ENGINEERING CHANGE NOTICE

Proj. ECN B-714-53

Block 5: B-714, GROUT VAULT PAIR (218-E-16-102 & 103)(218-E-16-104 & 105)/EDMC
Block 9: ECN B-714-17, B-714-22, B-714-30, B-714-42
Block 8: **AFFECTED DOCUMENTS (Drawings)**

13a. Justification (mark one)	13b. Justification Details
Criteria Change ■ Design Improvement ■ Environmental ☐ As-Found ☐ Facilitate Const. ■ Const. Error/Omission ☐ Design Error/Omission ■	CRITERIA CHANGE to separate Safety Class 2 & 3 wiring; ITEM #'s 6, 7, 17, 22, 23 & 34 (Ref WHC-SD-B714-W-QAPP-001, REV 4) ALL OTHER ITEMS are miscellaneous design improvements, drawing errors, design clarification and ease of construction changes.

KAISER ENGINEERS HANFORD	ENGINEERING CHANGE NOTICE SKETCH					
Ref. Dwg. H-2-77640	Sh. 1	Rev. 0	Prepared By A.R. SNOWHITE	Checked By	ECN No. B-714-53	Page 35/49

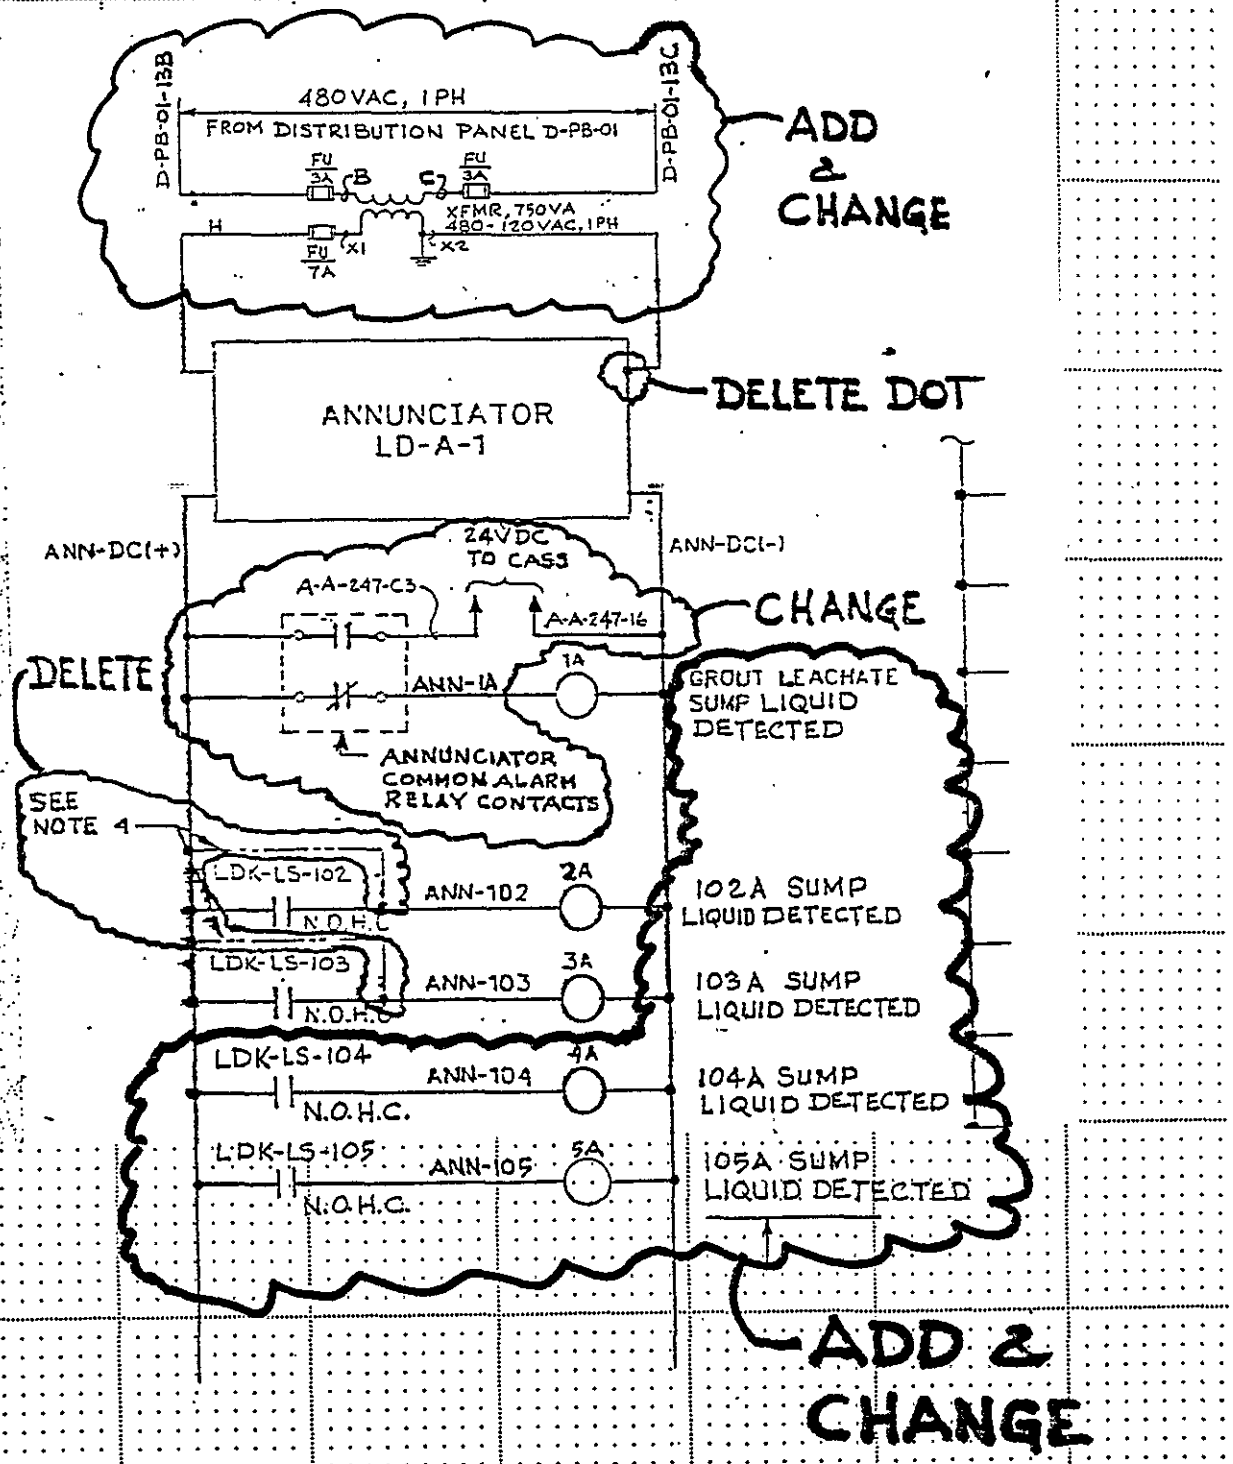
16) H-2-77640, SH 1, REV 0
A) ELEMENTARY DIAG (ZE7-F8): Modify - see page 35 of this ECN
B) ENGRAVING CHART (ZF5): Add the following

Ref. Dwg. H-2-77642 | Sh. 1 | Rev. 0 | Prepared By A.R. SNOWHITE | Checked By | ECN No. B-714-53 | Page 36/49

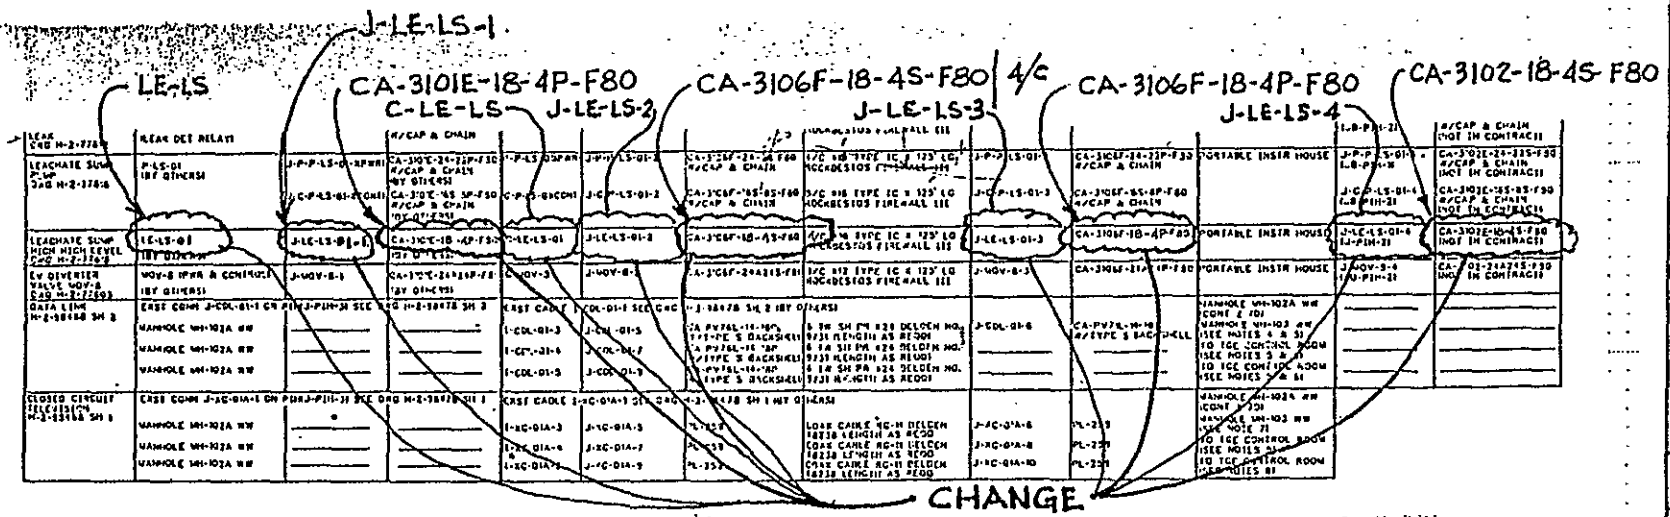
A) CONNECTOR SCHEDULE: LEACHATE SUMP TEMPERATURE (affects ECN B-714-17)
CHANGE/ADD columns as shown on page **36** of this ECN

E) CONNECTOR SCHEDULE FOR LEACHATE SUMP HIGH-HIGH LEVEL:
Modify - see page **36** of this ECN

KAISER ENGINEERS HANFORD	ENGINEERING CHANGE NOTICE SKETCH					
Ref. Dwg. H-2-78500	Sh. 1	Rev. 0	Prepared By A.R. SNOWHITE	Checked By	ECN No. B-714-53	Page 37/49

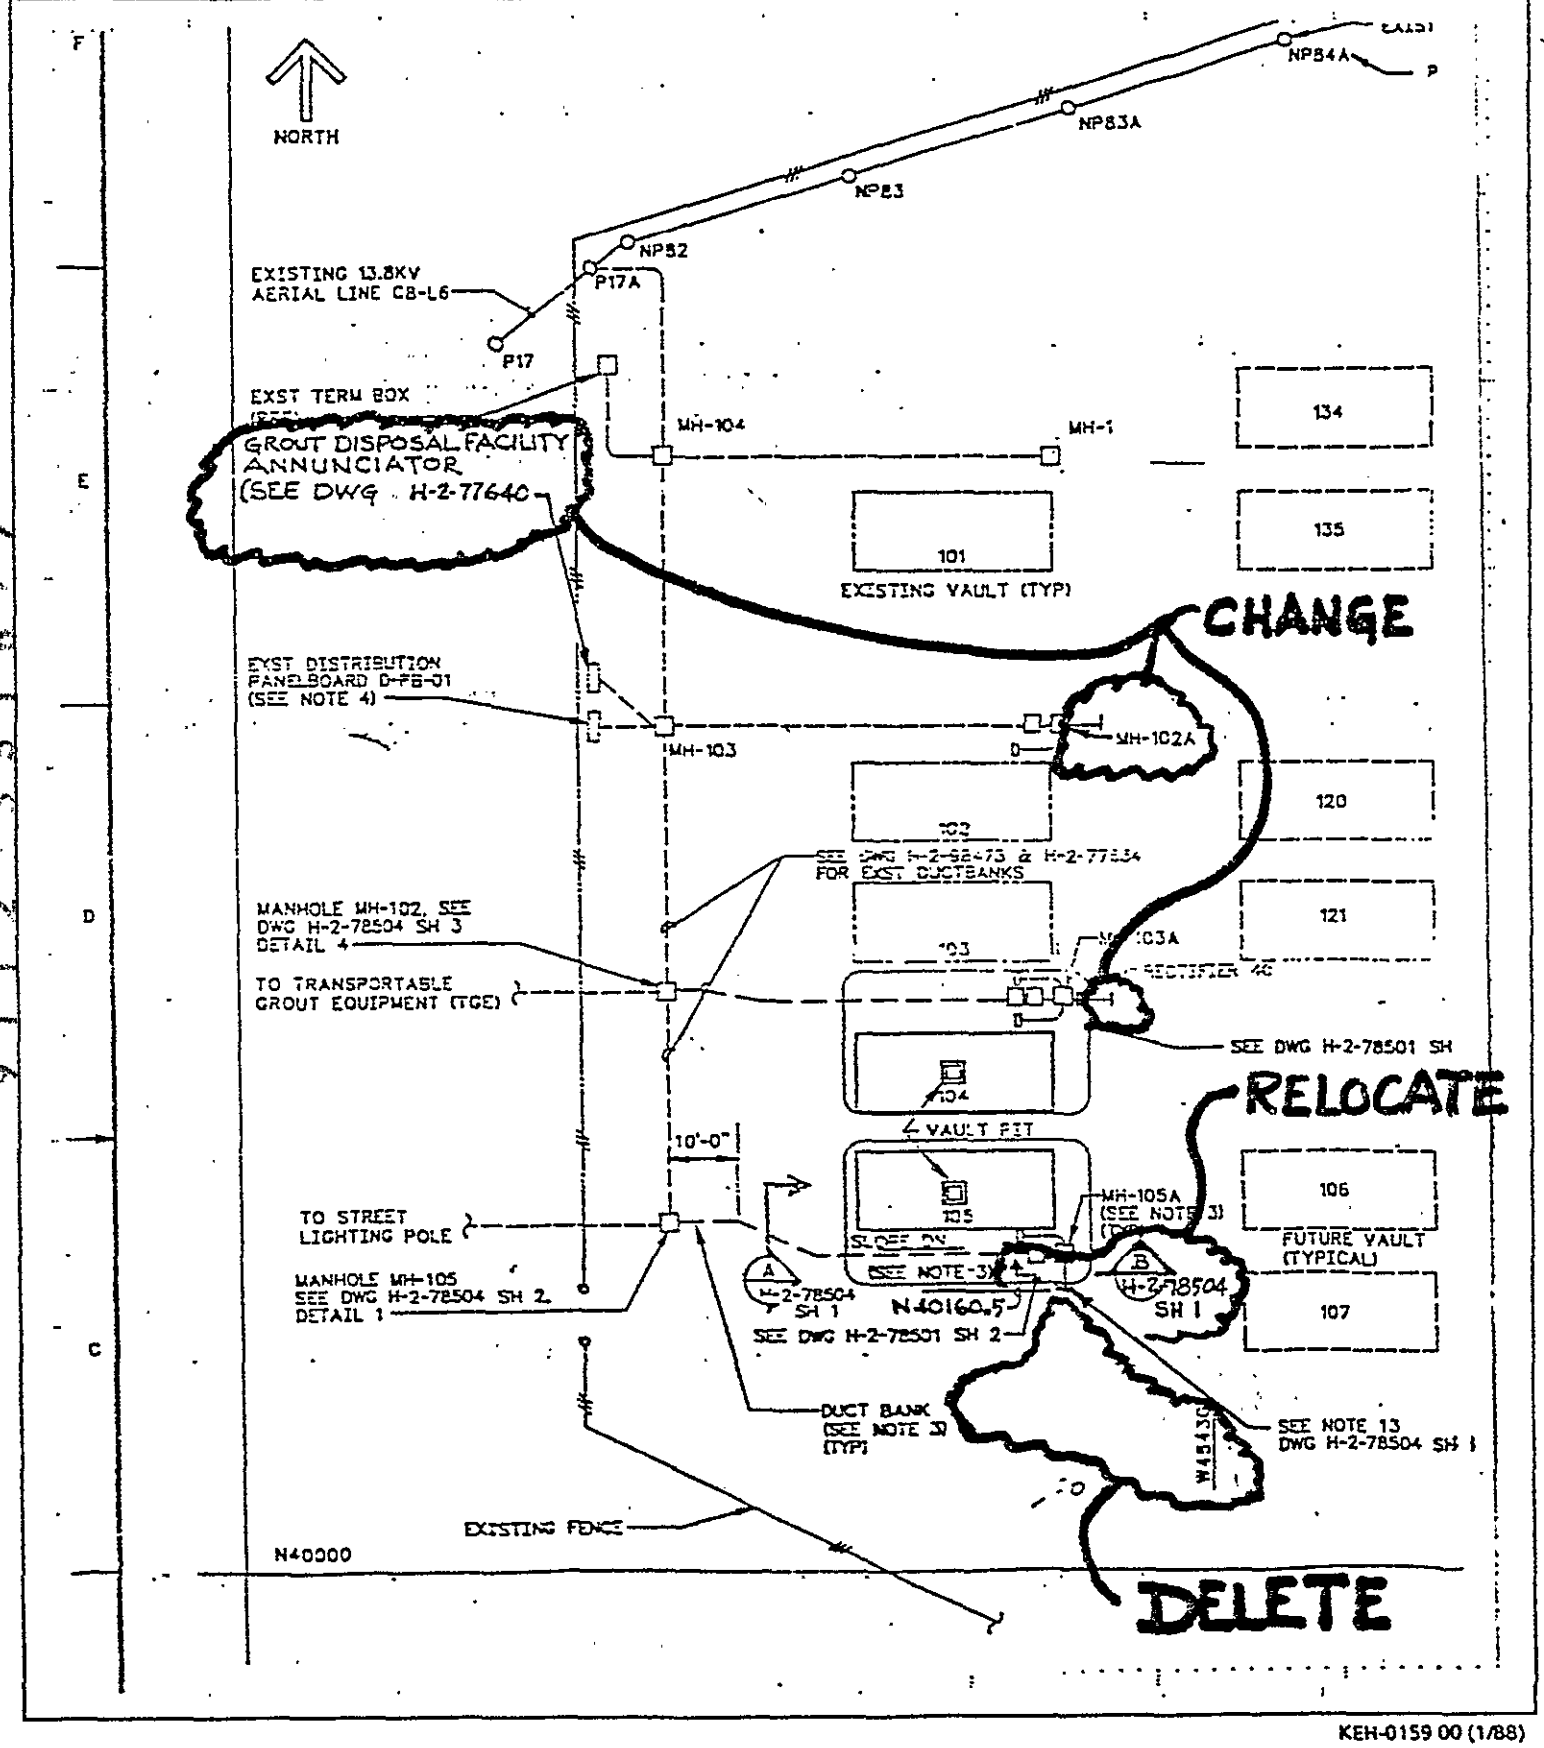
21) H-2-78500, SH 1, REV 0 (affects ECN B-714-30, pg 12)
A) PLAN (ZE8, D6, C6): Modify - see page 37 of this ECN
B) REFERENCE BLOCK: Add H-2-77640 ELEC ELEM DIAG LEAK DET ANN

KAISER ENGINEERS HANFORD	ENGINEERING CHANGE NOTICE SKETCH					
Ref. Dwg. H-2-78501	Sh. 1	Rev. 0	Prepared By A.R. SNOWHITE	Checked By	ECN No. B-714-53	Page 38/49

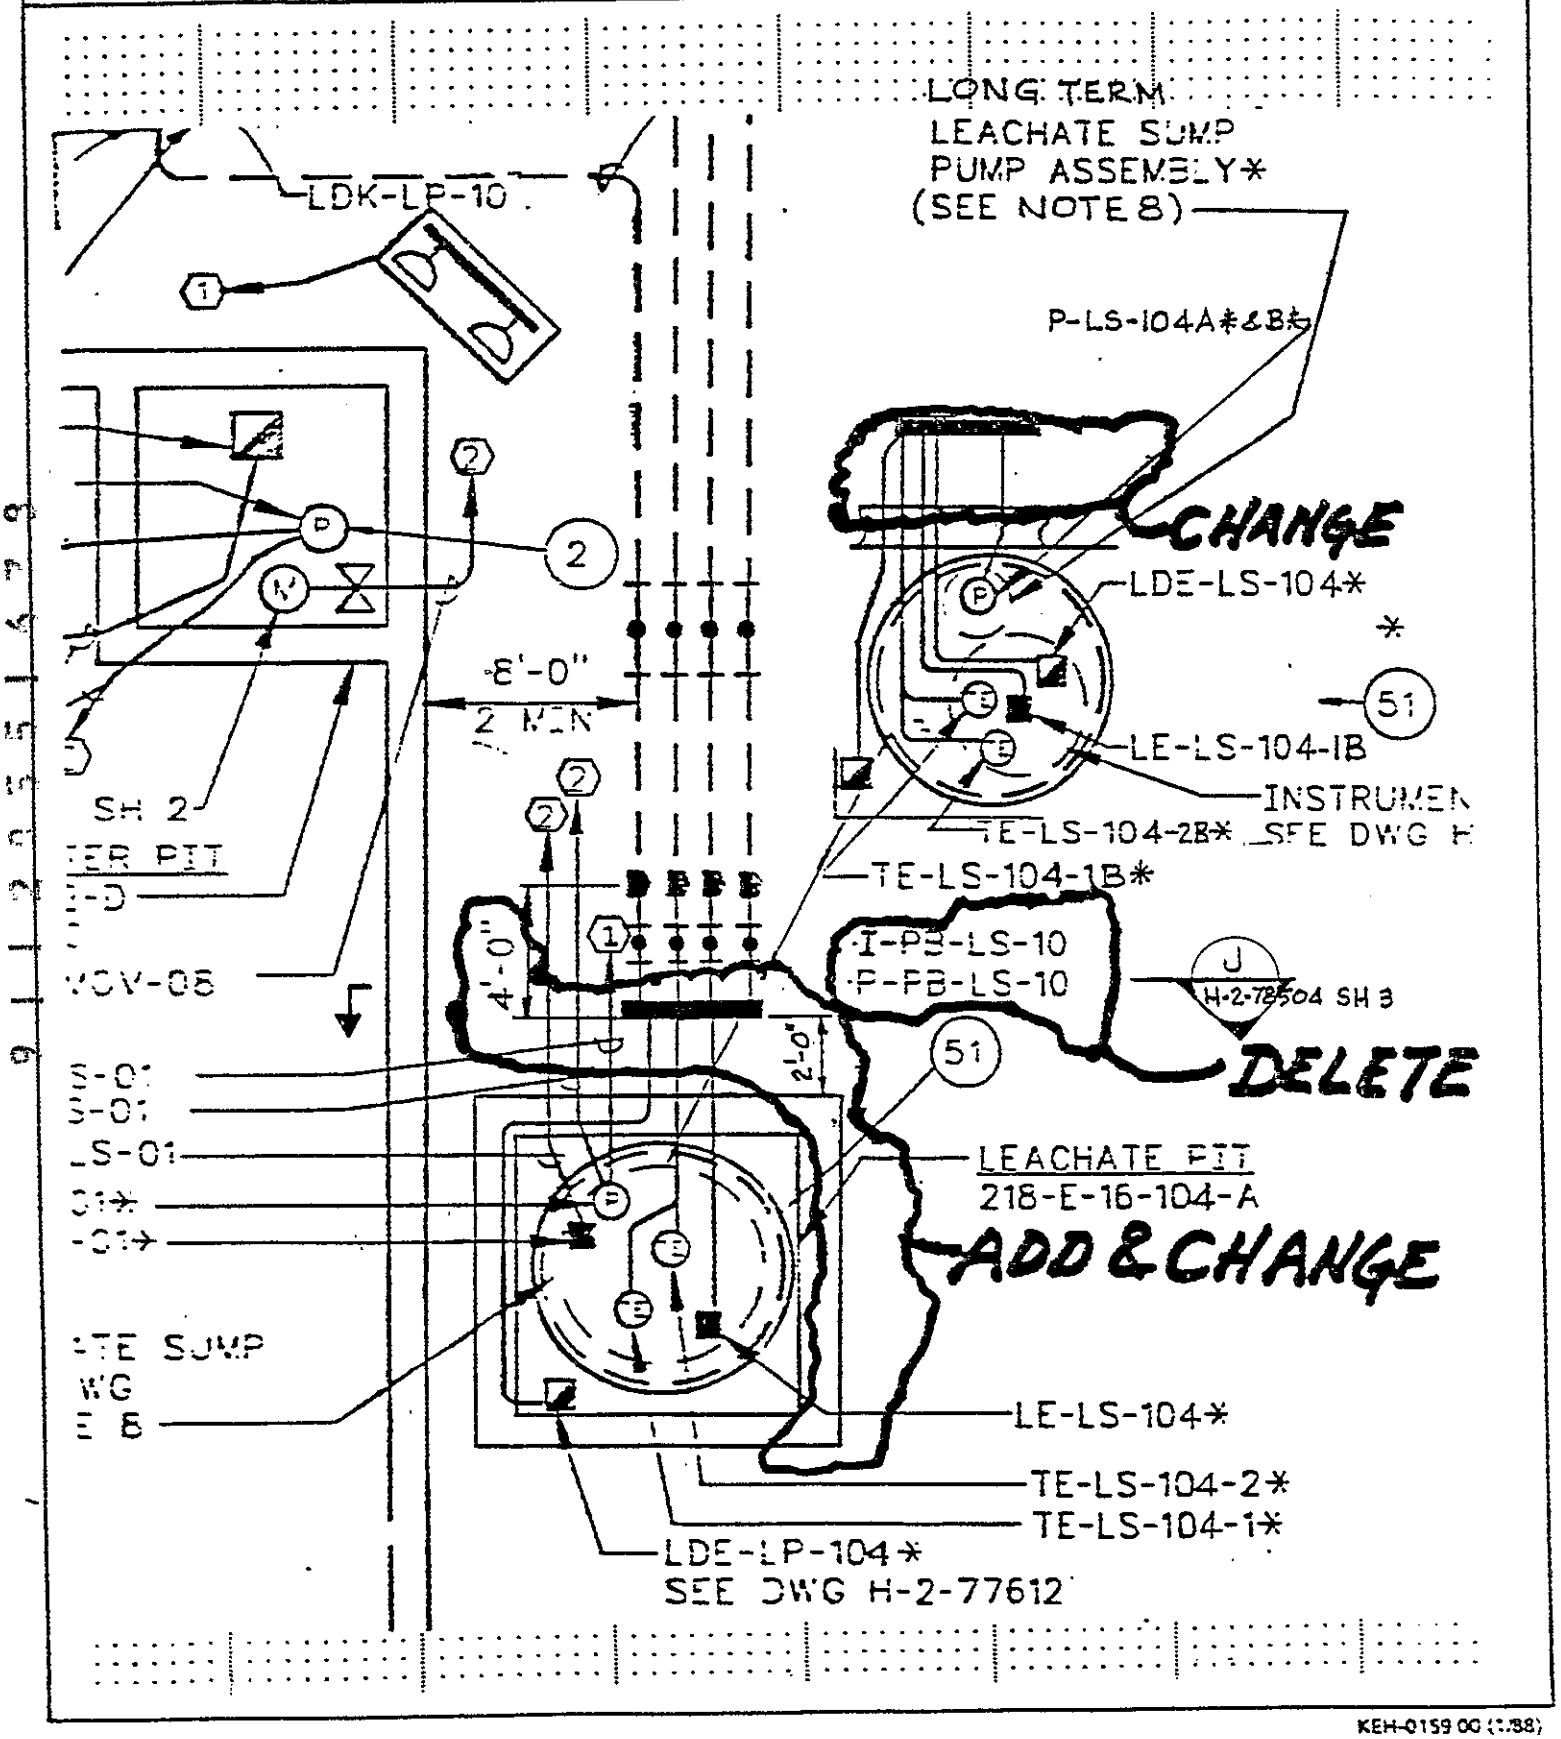
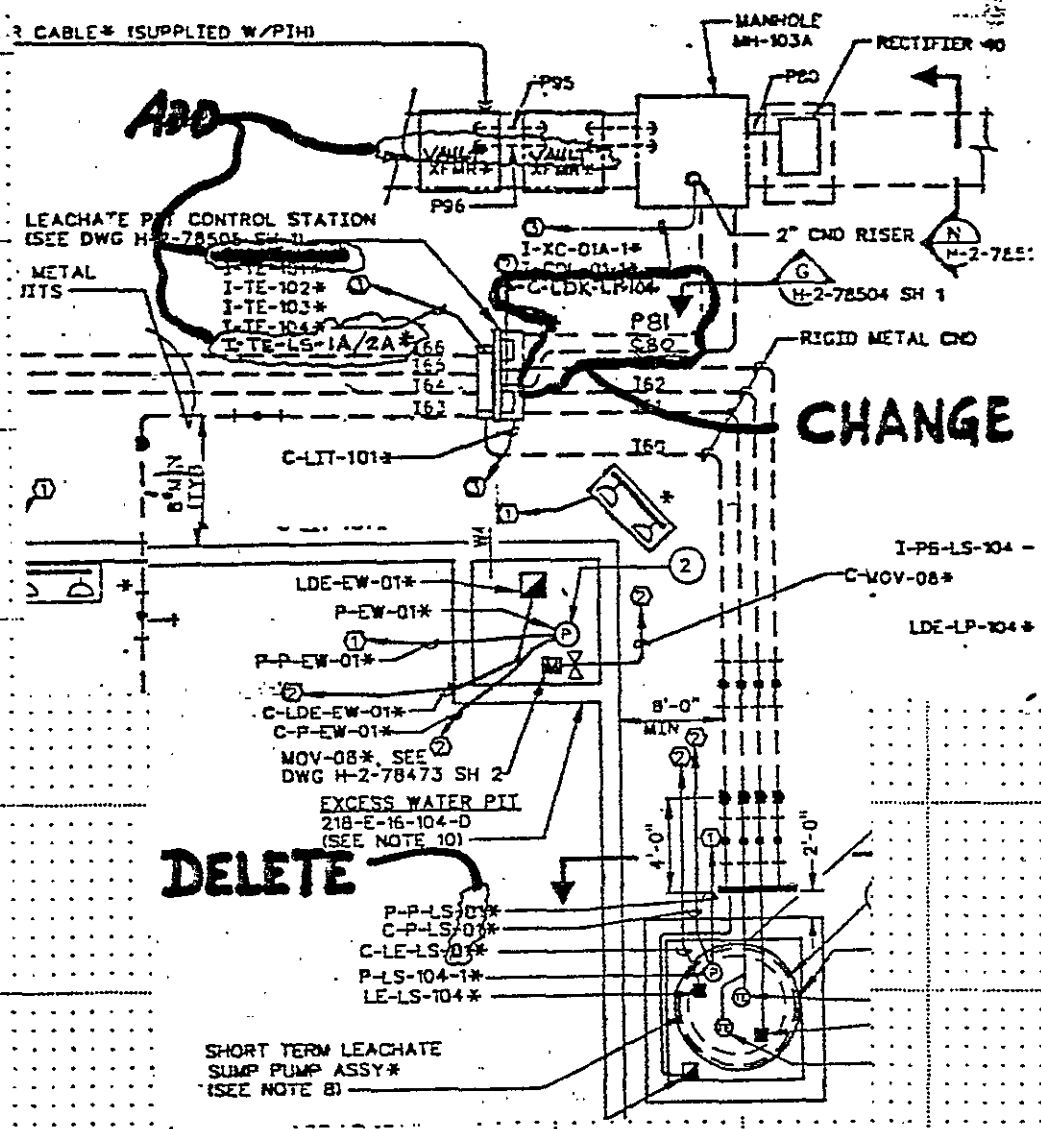
22) H-2-78501, SH 1, REV 0
A) PLAN (ZE3, E2, D2-3): Modify - see page 38 & 39 of this ECN
B) NOTE 9 (ZB1): Change "GRAVEL COCOON" to "DIFFUSION MATERIAL"
C) (ZE3): Change C-LDK-LP-01* to C-LDK-LP*
